Subject: Transmittal of Class 1 Permit Modification to Update Figures in the Los Alamos National Laboratory (LANL) Hazardous Waste Facility Permit, EPA ID No. NM0890010515

CLASS 1 PERMIT MODIFICATION NOTIFICATION STRUCTURE CHANGES AT TECHNICAL AREA 54

ENV-DO-14-0023

LAUR-13-29257

Figure 33: Technical Area (TA)-54, Area G, Pad 6, (Domes 153 & 283)

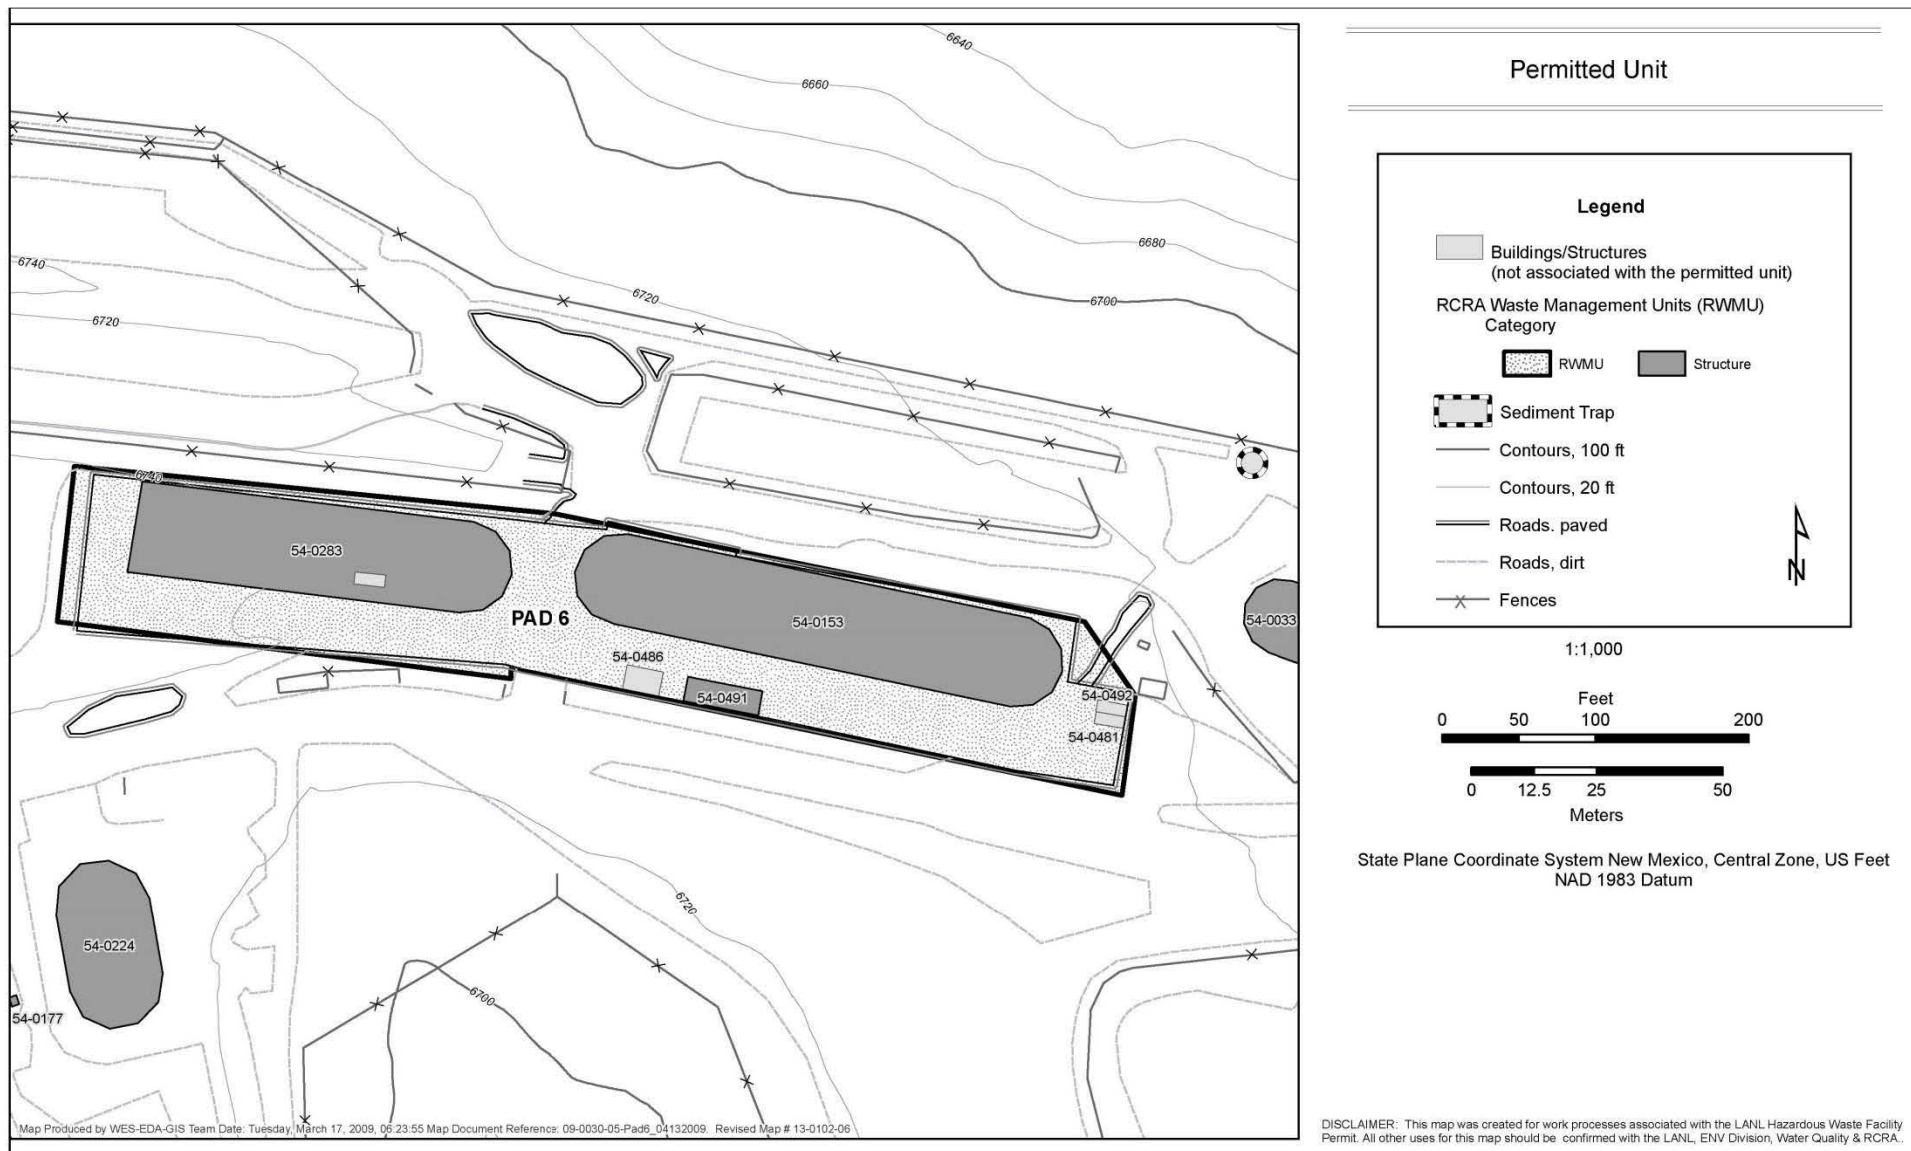
Figure G.9-1 (Technical Area 54, Area G, Pad 6 Outdoor Container Storage Unit Sampling Grid and Additional Sampling Locations) of Attachment G.9 and Figure 33 (Technical Area (TA)-54, Area G, Pad 6, (Domes 153 & 283)) of Attachment N were revised to remove structures 54-522 and 54-523. These structures were designated as structures that were not associated with the permitted unit and were not used to manage hazardous waste. The figure was also updated to reflect the addition

of a structure on the inside of structure 54-0283 that is not used to manage hazardous waste at the permitted unit.

Figure G.10-1: Technical Area 54, Area G, Pad 9 Outdoor Container Storage Unit Grid Sampling and Additional Sampling Locations

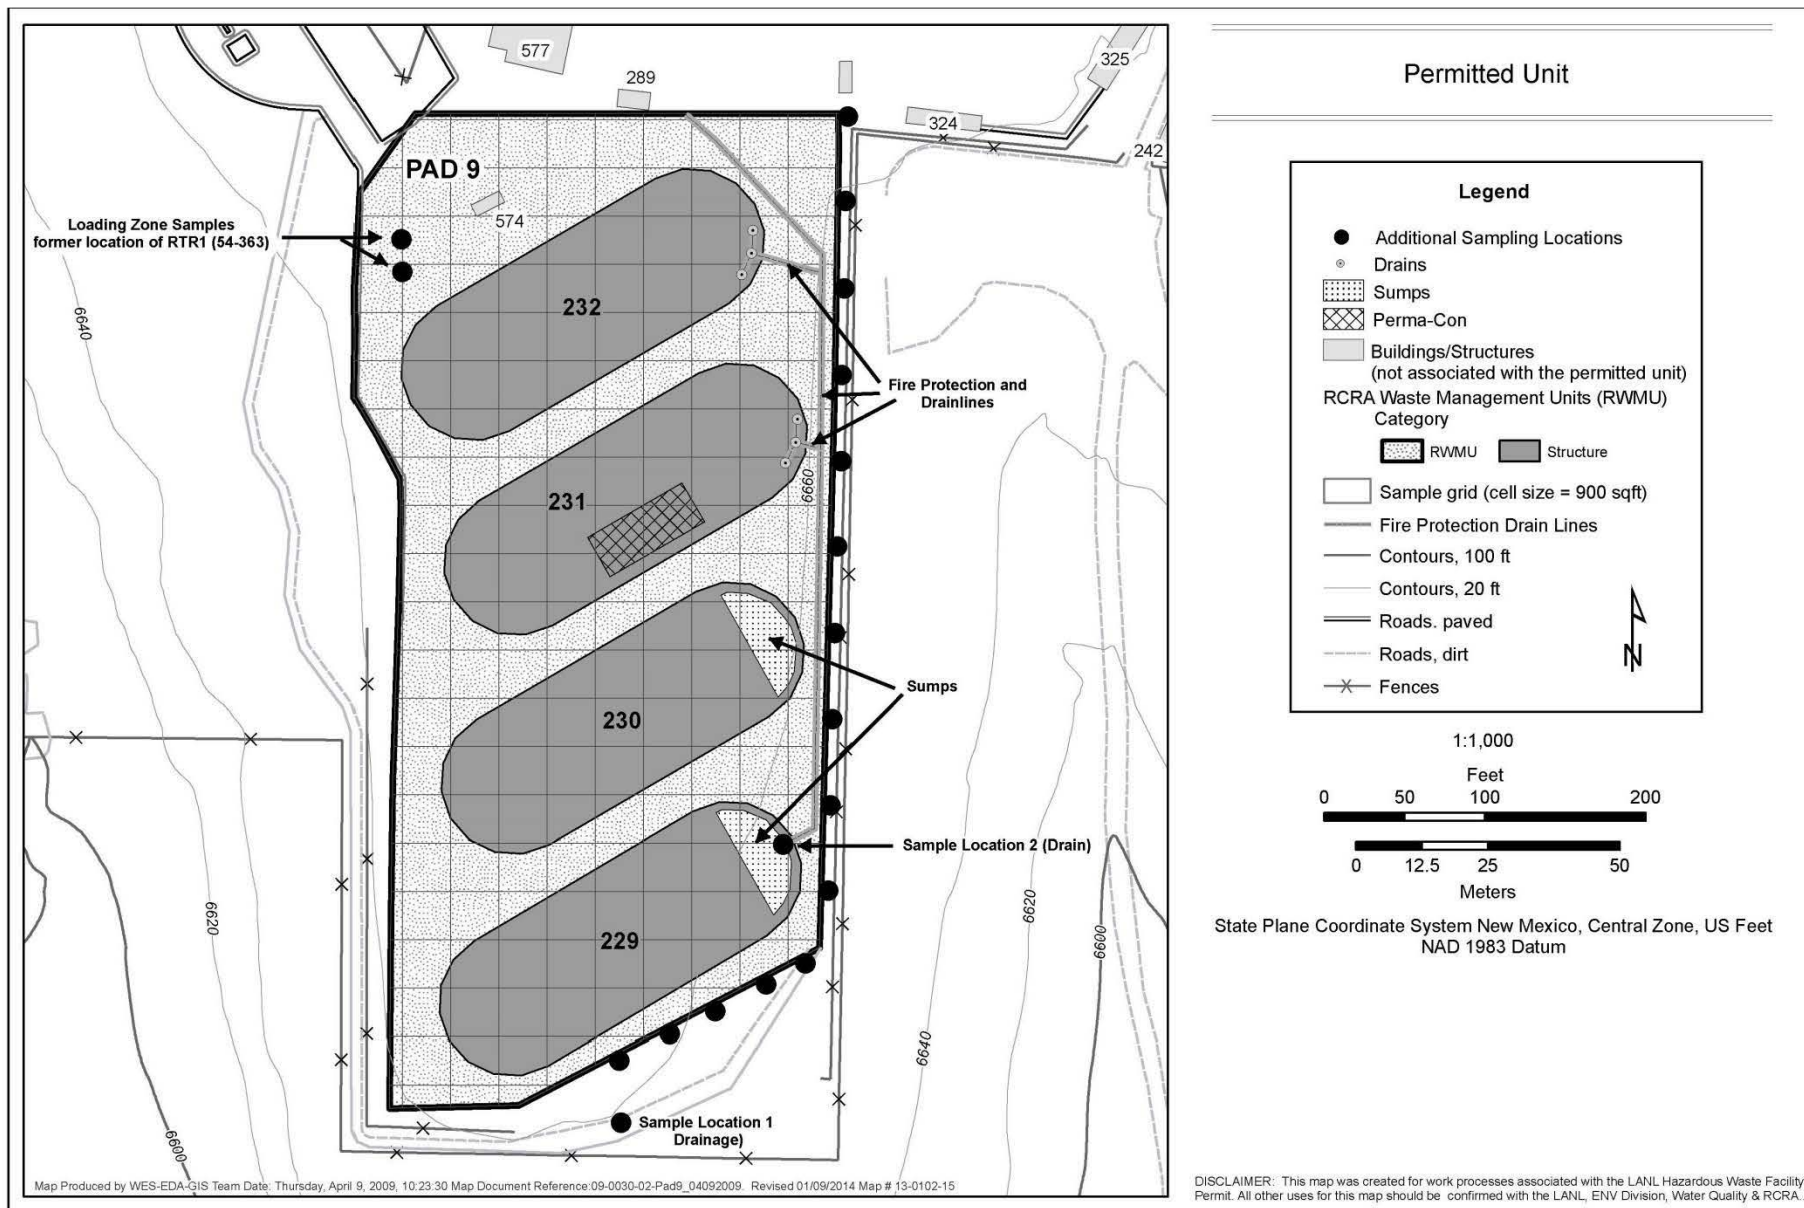
Figure G.10-1 (Technical Area 54, Area G, Pad 9 Outdoor Container Storage Unit Grid Sampling and Additional Sampling Locations) of Attachment G.10 and Figure 28 (Technical Area (TA)-54 Area G, Pad 9, (TWISP Domes 229, 230, 231 & 232)) of Attachment N were revised to remove storage shed 54-484 from Pad 9 and to show that storage shed 54-574 was relocated to an area northwest of Dome 232. These storage sheds are designated as structures that are not associated with the permitted unit and are not used to manage hazardous waste.

Figure 34: Technical Area (TA)-54, Area G, Storage Shed 8

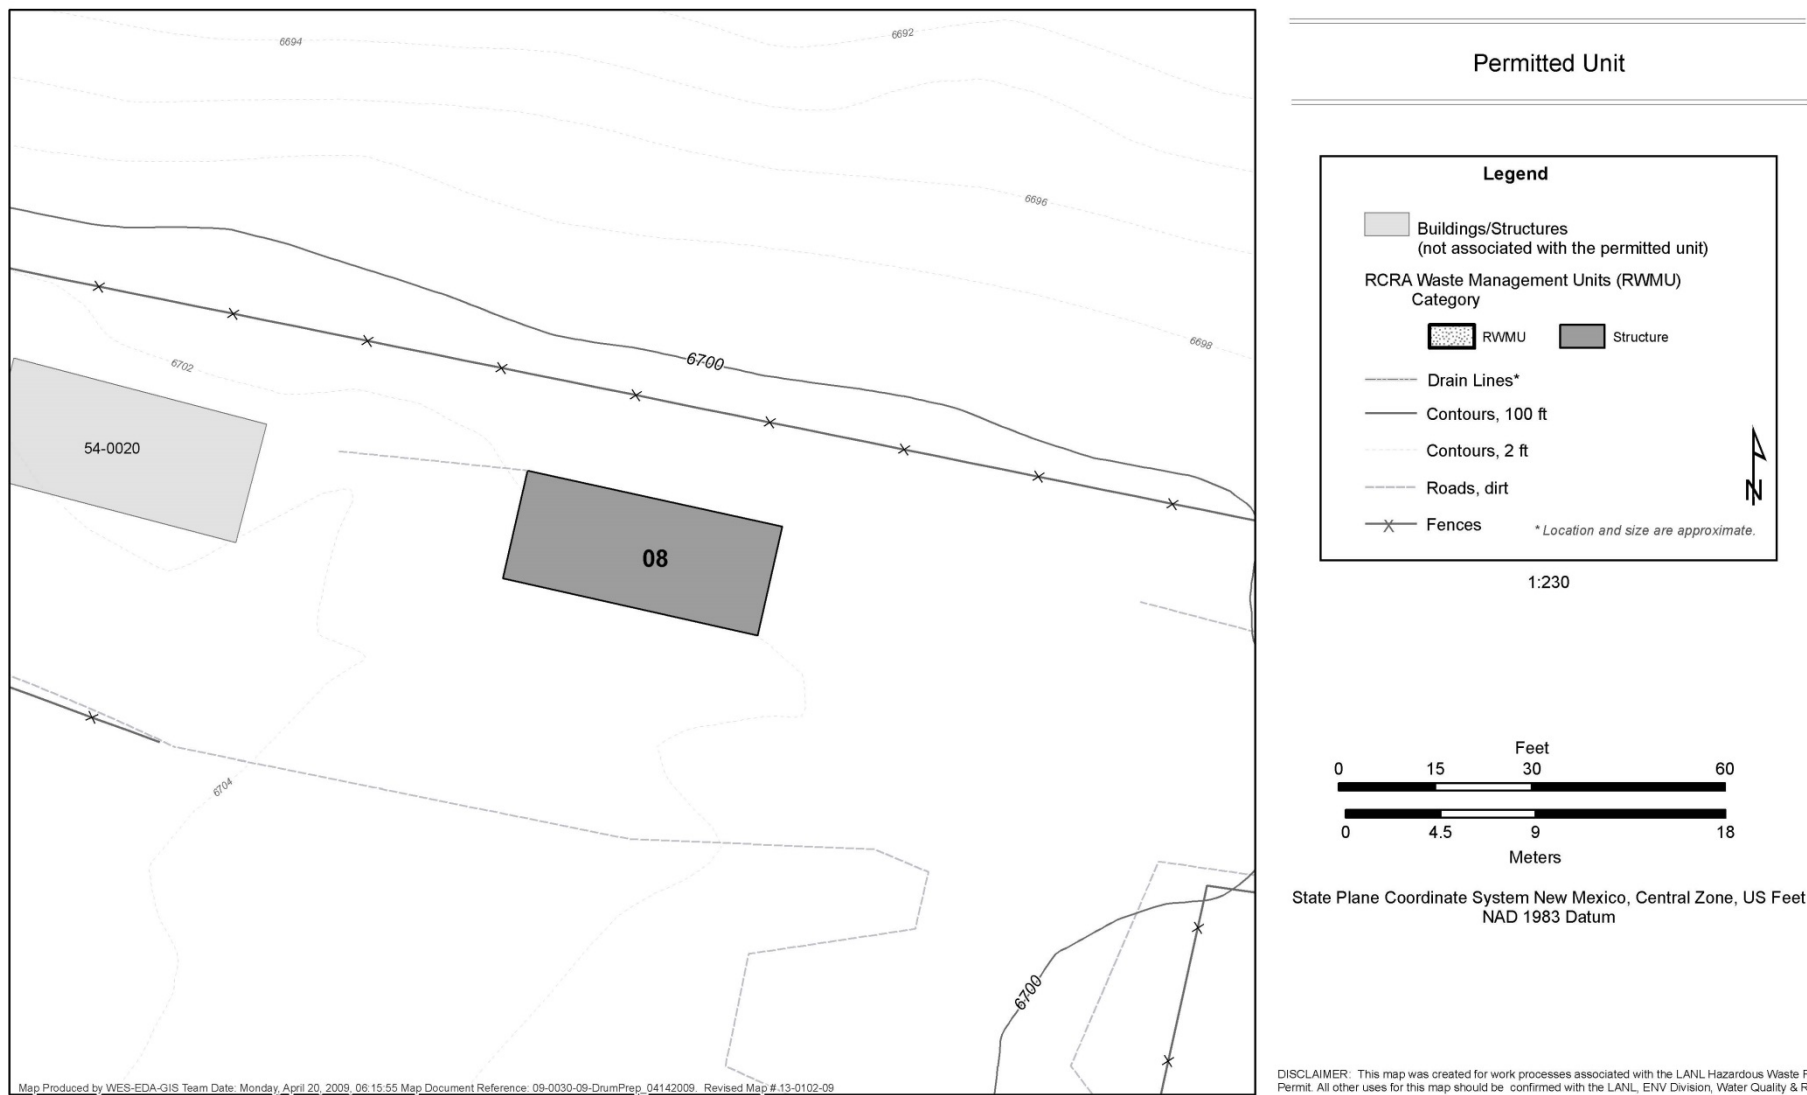
Figure 34 (Technical Area (TA)-54, Area G, Storage Shed 8) did not include a legend or scale. Therefore, this figure was revised to provide map details.

Figure G.12-1: Technical Area 54, Area G, Pad 11 Outdoor Container Storage Unit Grid Sampling and Additional Sampling Locations

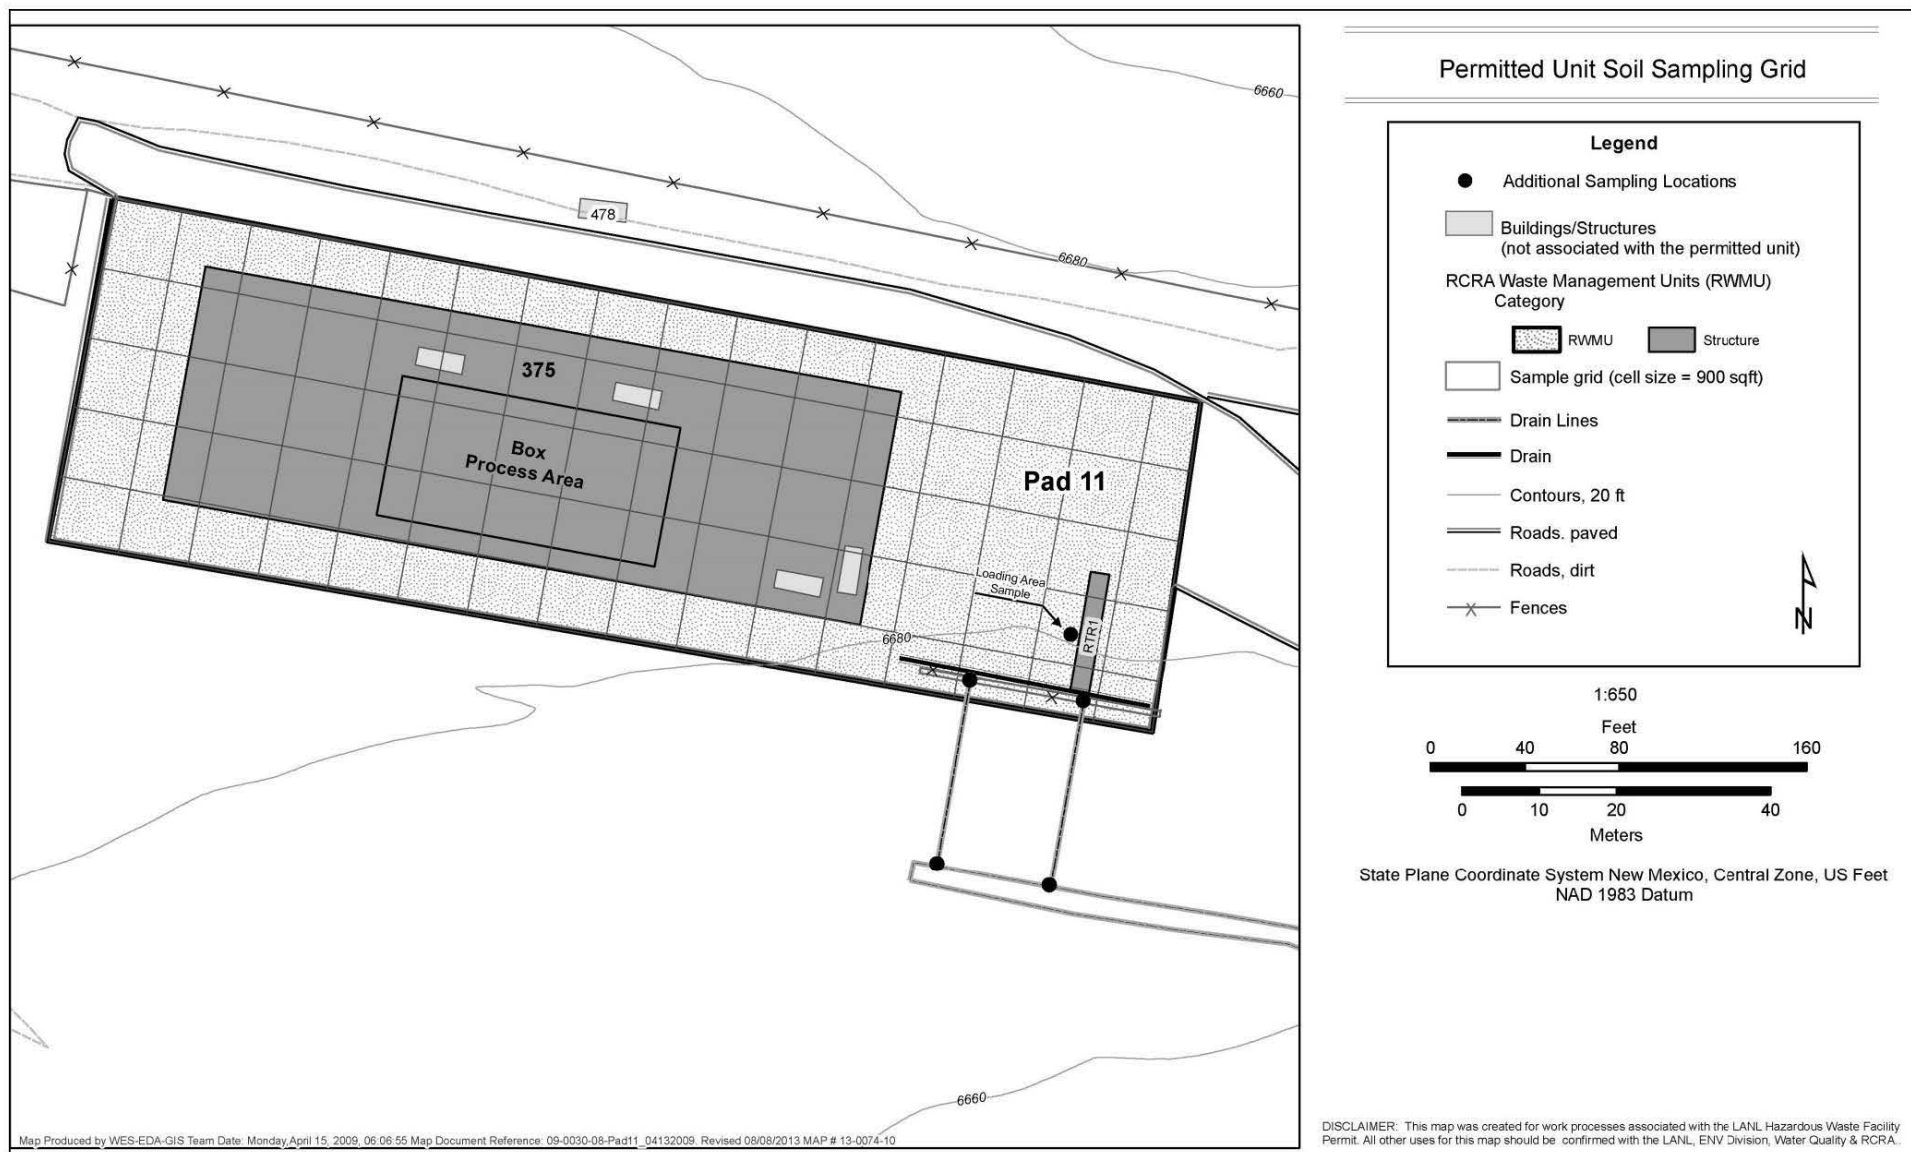
Figure G.12-1 (Technical Area 54, Area G, Pad 11 Outdoor Container Storage Unit Grid Sampling and Additional Sampling Locations) of Attachment G.12 and Figure 36 (TA-54, Area G, Pad 11) of Attachment N were revised to remove structure 54-57 from the southwest corner of the pad as well as the three concrete barricades (XXX3, XXX4 and XXX5) located on the northeast portion of the pad. Structure 54-57 was designated as a structure not associated with the permitted unit and it was not used to manage hazardous waste.

Figure G.17-1: Technical Area 54 West Outdoor Container Storage Unit Grid Sampling and Additional Sampling Locations

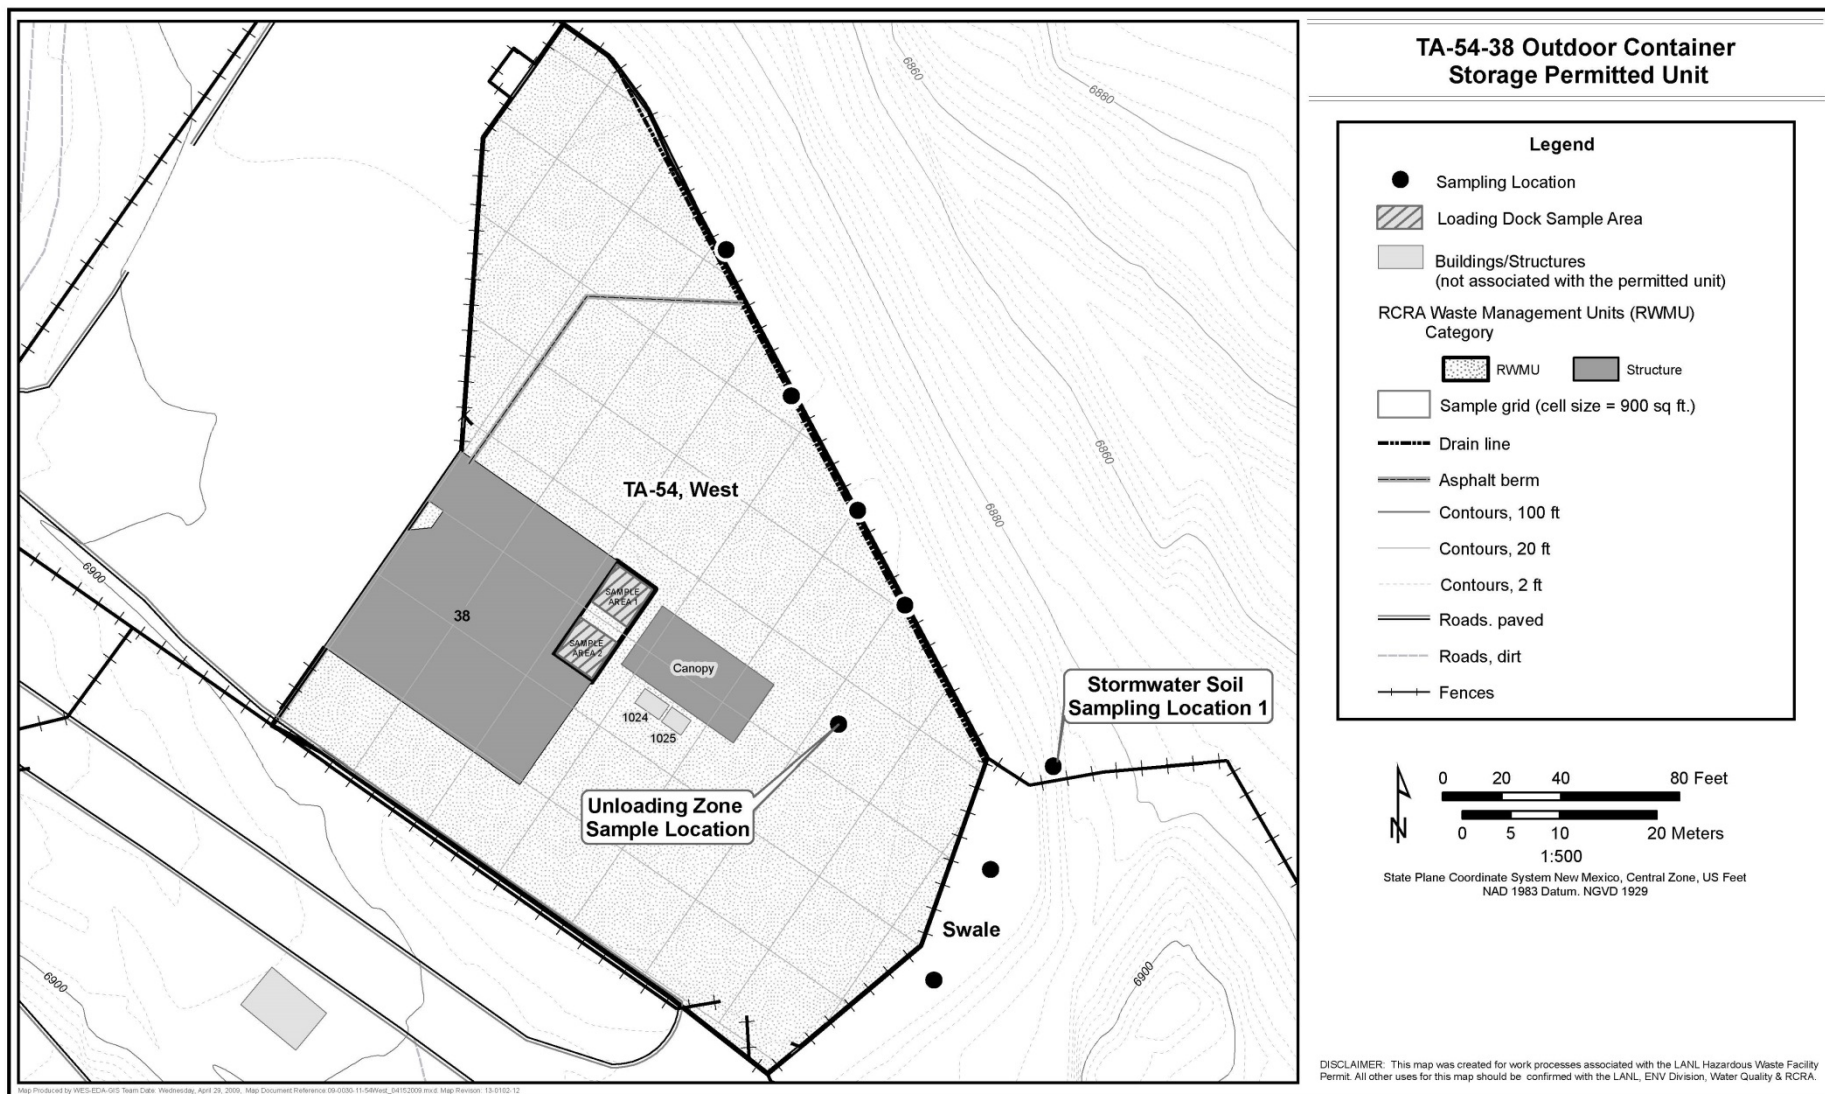
Figure G.17-1 (Technical Area 54, West Outdoor Container Storage Unit Grid Sampling and Additional Sampling Locations) of Attachment G.17 was revised to remove structures 54-34 and 54-455 (these structures were located outside of the permitted unit) and to make the fence line continuous along the northwest boundary of the permitted unit. Structure 54-34 previously served as part of the fence line boundary for the permitted unit. The structure was removed and the fence around the unit was completed to demarcate the boundary of the permitted unit.
